**Public Input No. 3085, Assigned to Code-Making
Panel 1, Refer to Code-Making Panels 2 - 18**

Public Input No. 3085-NFPA 70-2023 [Global Input]

**Public Input No. 3086, Assigned to Code-Making
Panel 2, Refer to Code Making Panels 3 - 18**

TCC Name: <u>_MOTORS</u>	Current x 0.1	Reference Voltage: 480
Online: <u>_MOTORS</u>		
Date: Mav 12. 2023 10:54 AM		SKM Svstems Analvsis. Inc.

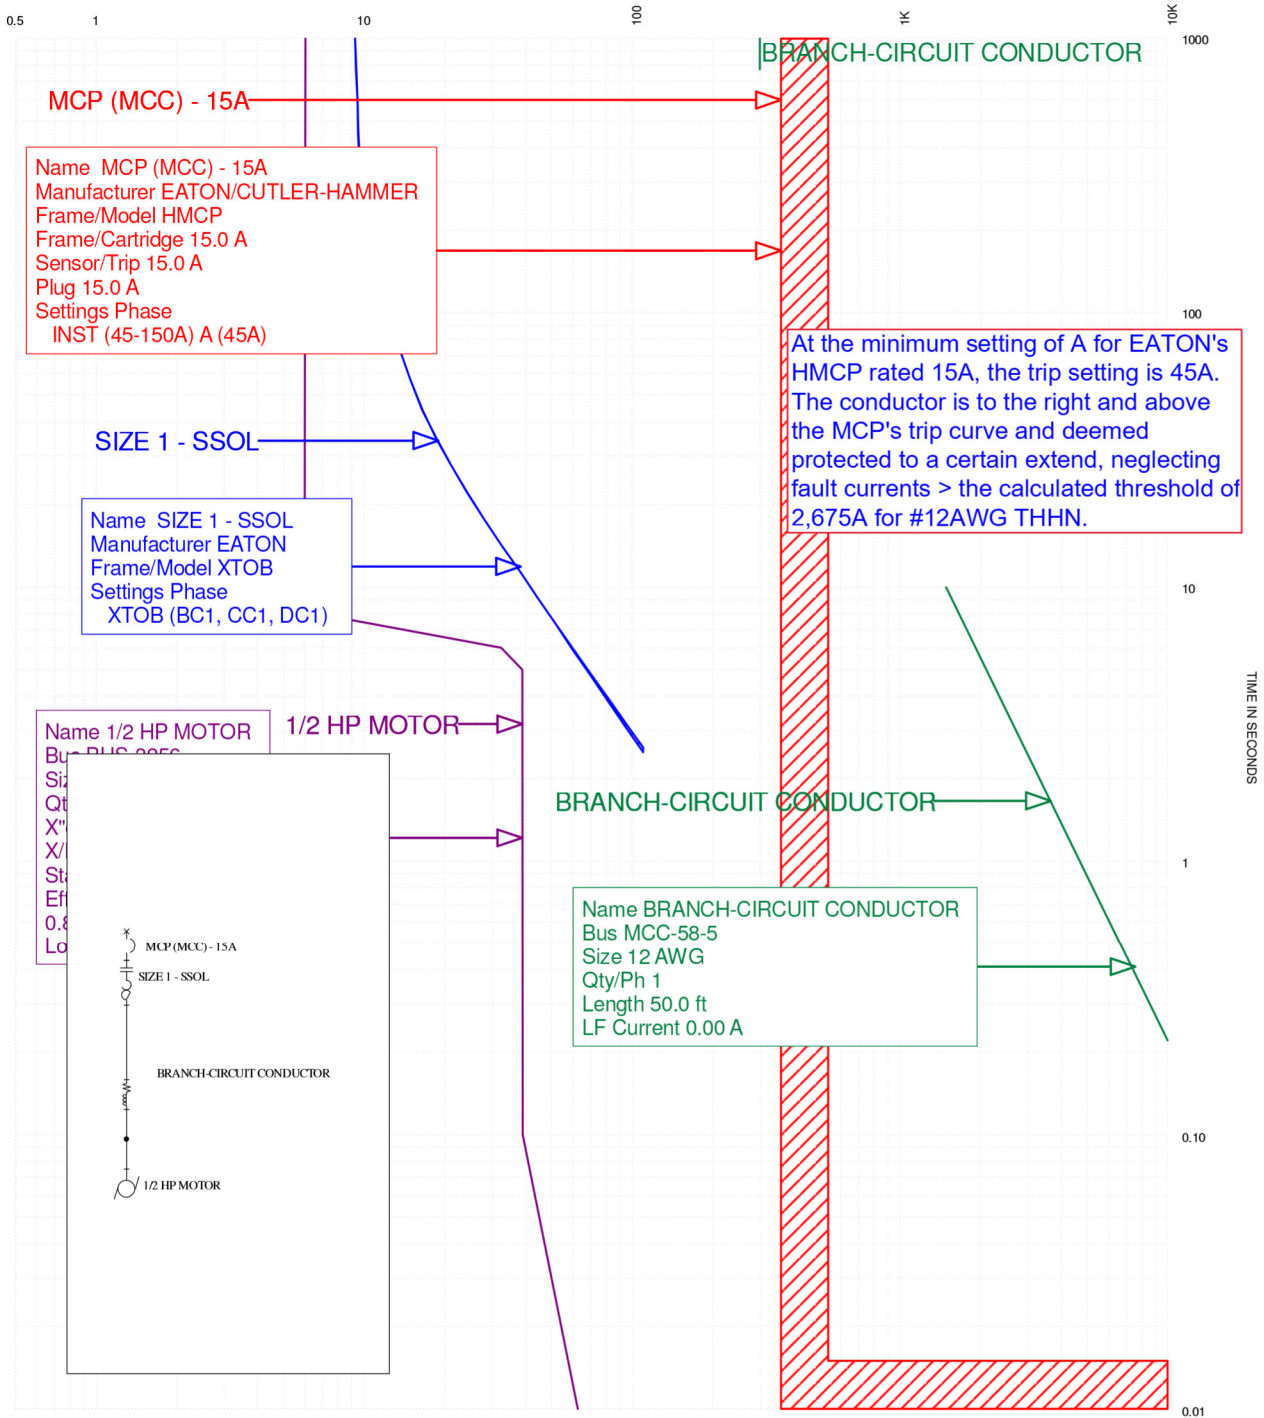
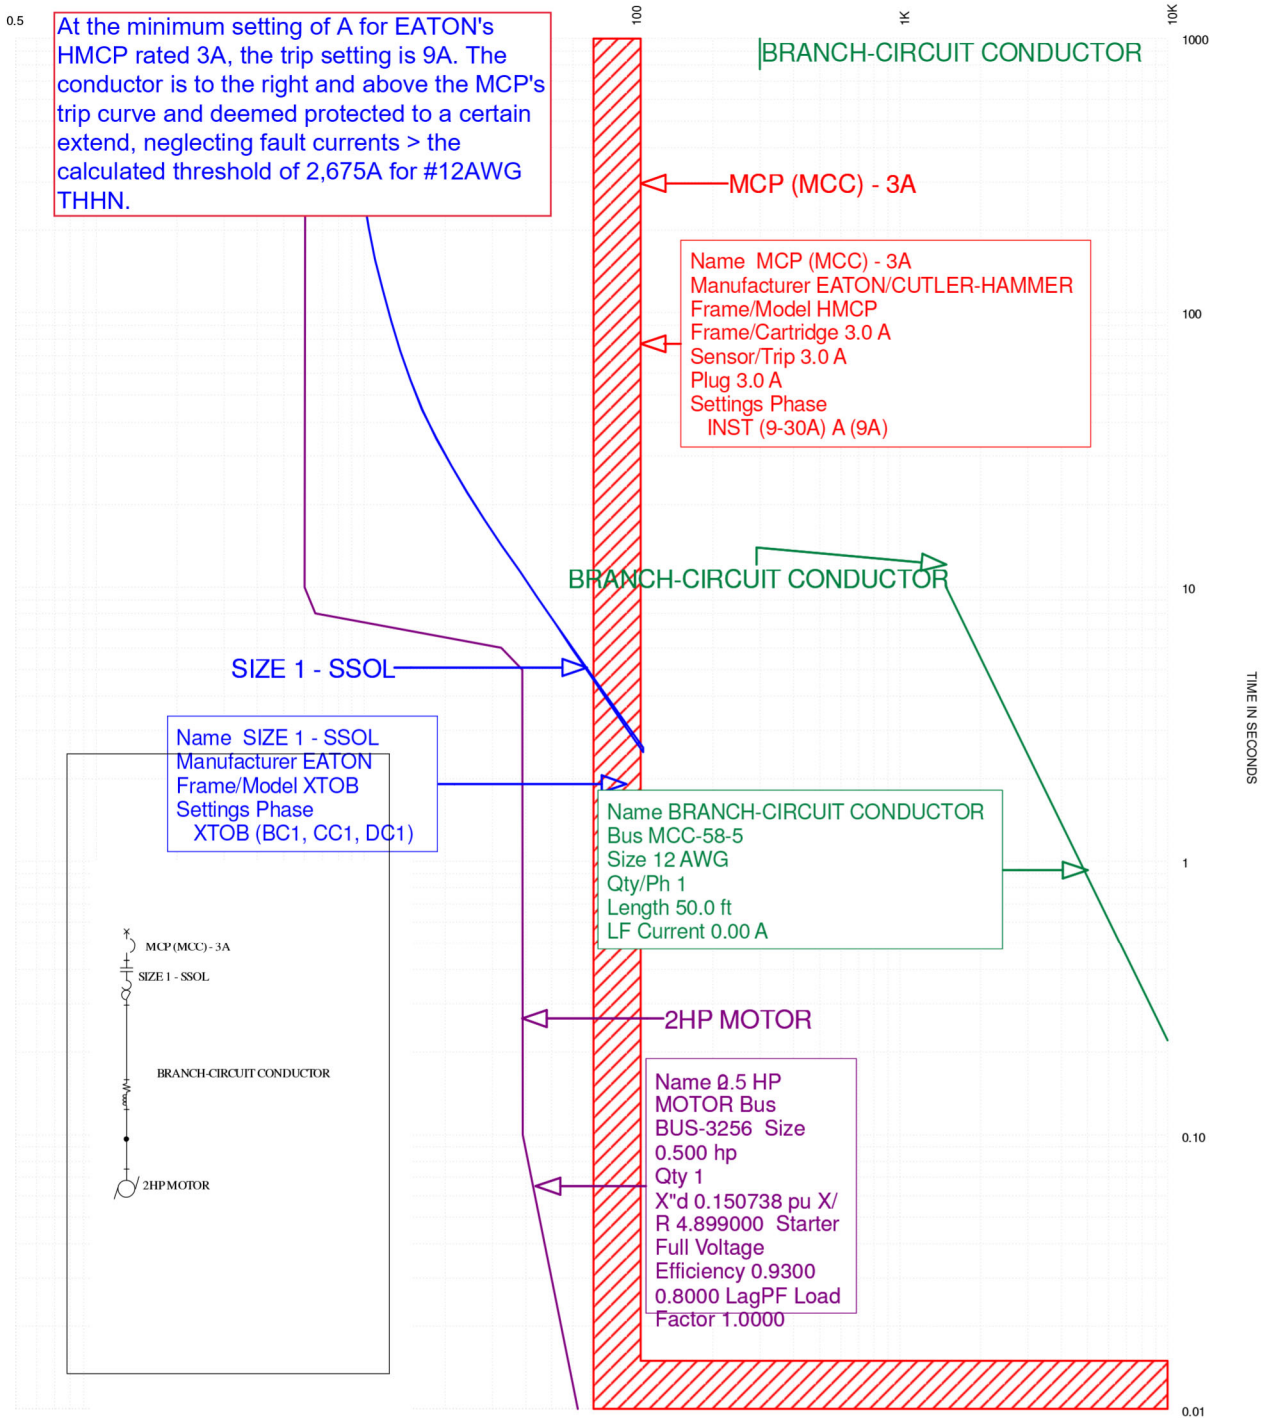
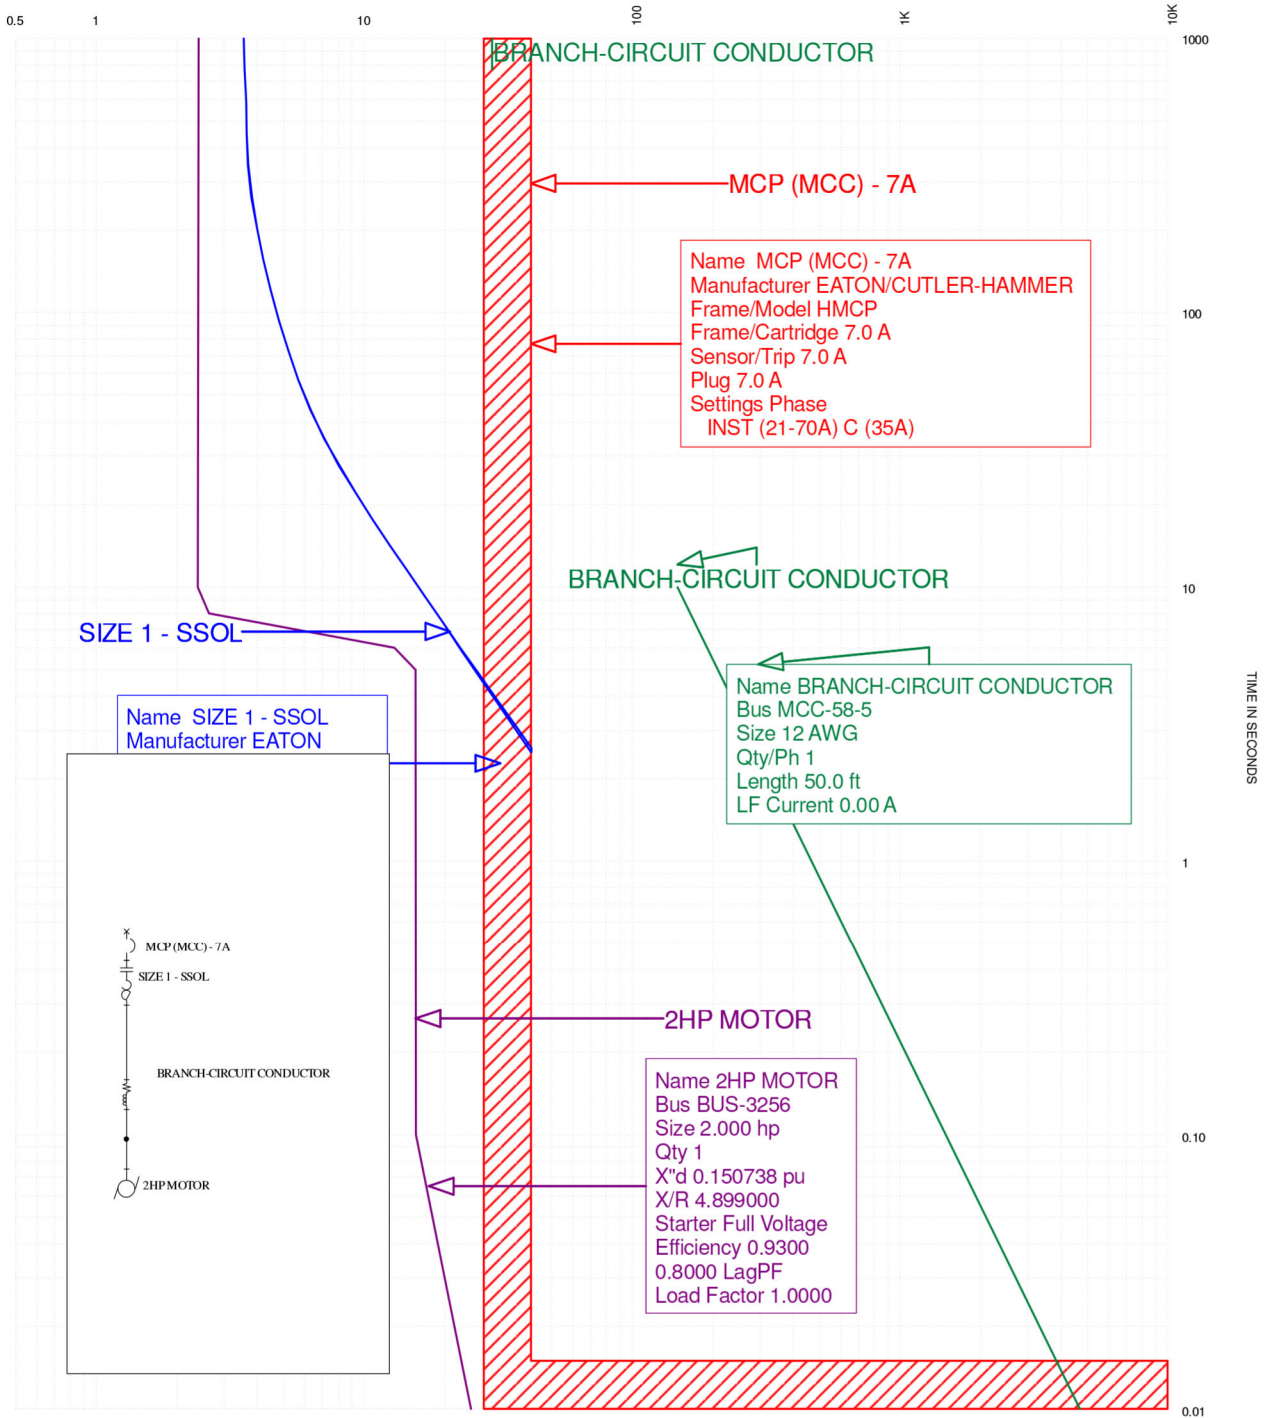
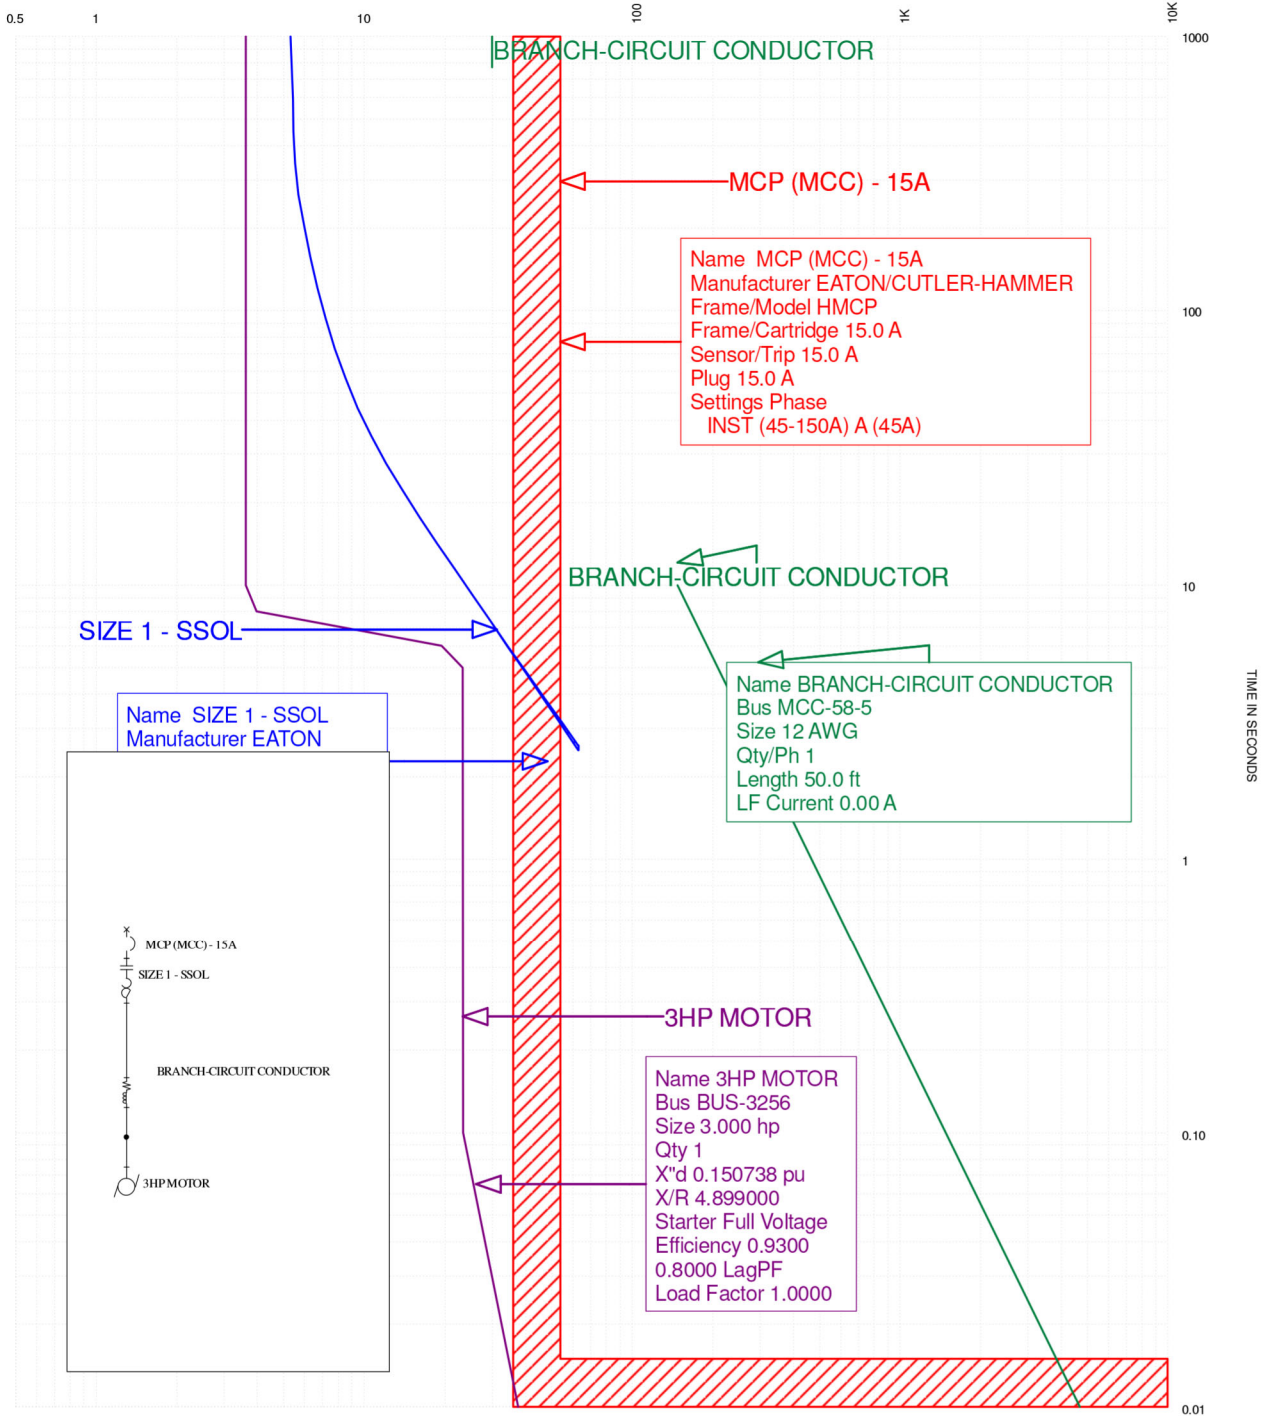
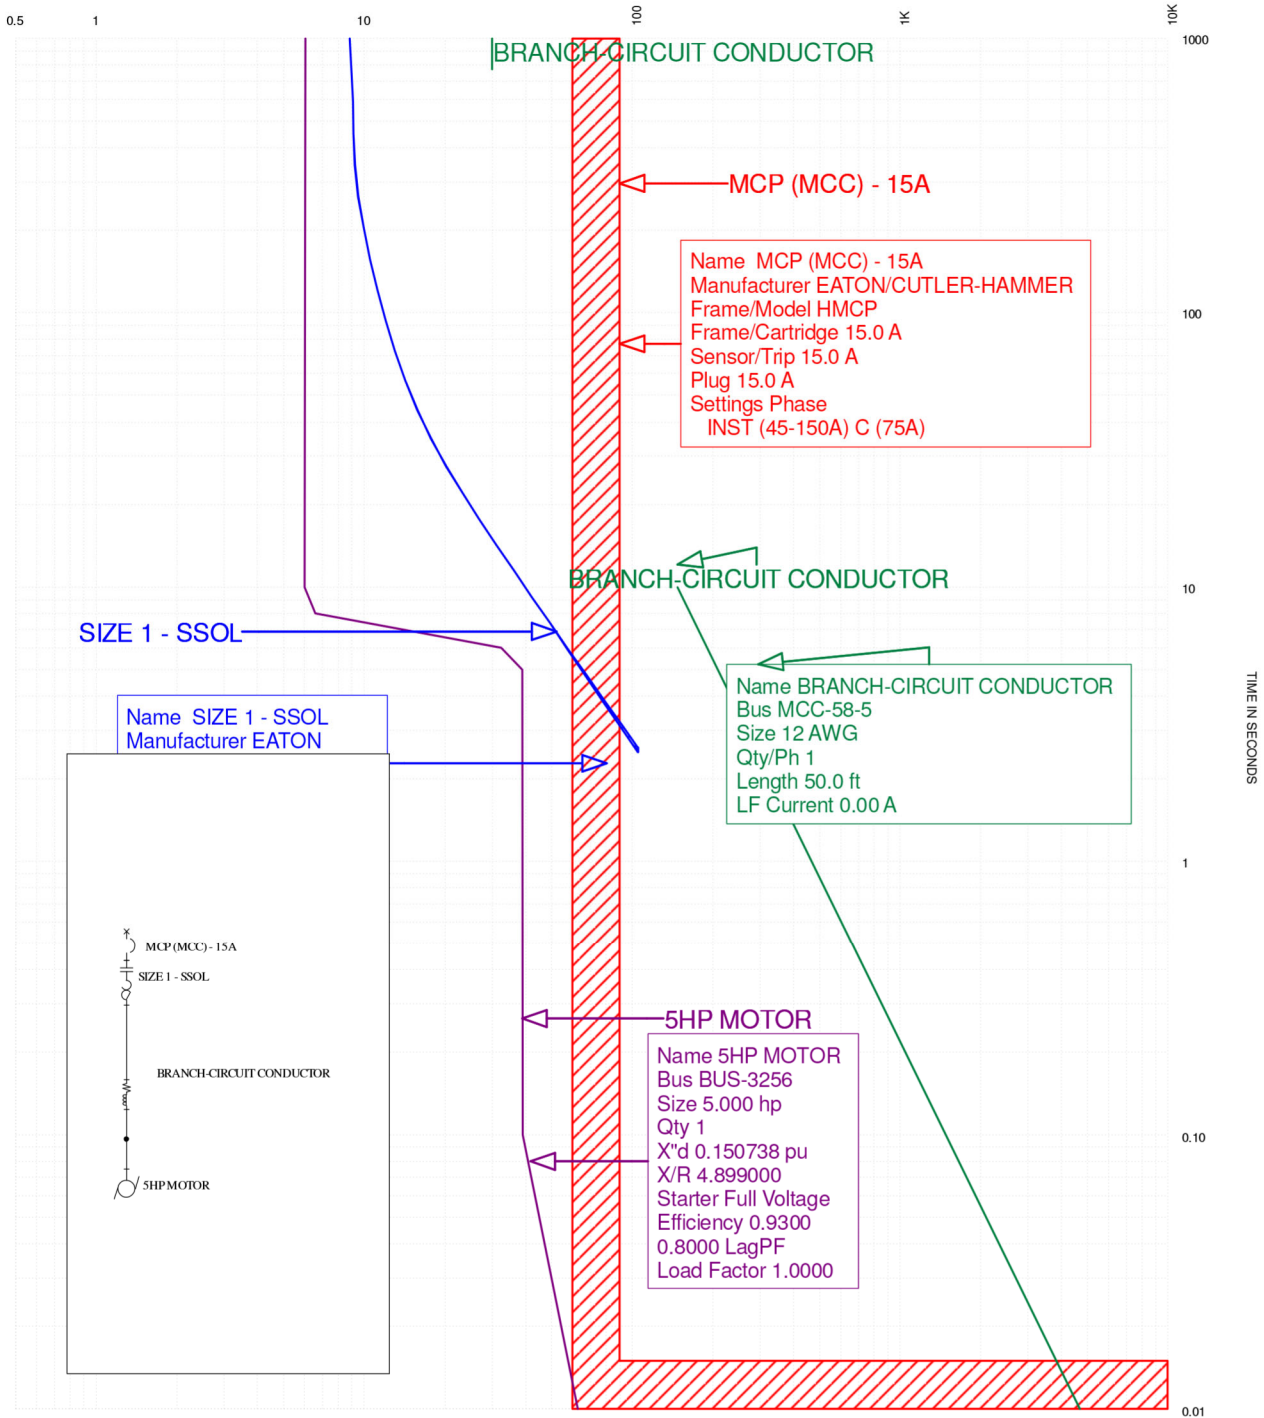
In 430.52(C)(3)(b)(2)a. of the 2023 National Electrical Code, a value of 1300 percent is specified for all motor types in Table 430.52(C)(1) other than Design B energy efficient and Design B premium efficiency. Since the introduction of Design BE and CE introduces a new exception to the 1300 percent specification, it is proposed to specify a value for each of the motor types shown in Table 430.52(C)(1) instead of specifying a single value with a list of exceptions. This does not change the adjustable instantaneous-trip setting specified in 430.52(C)(3)(b)(2) of the 2023 National Electrical Code for any motor type with the exception of the Design BE and CE, energy-efficient Design C, and premium efficiency Design C motor types already mentioned.
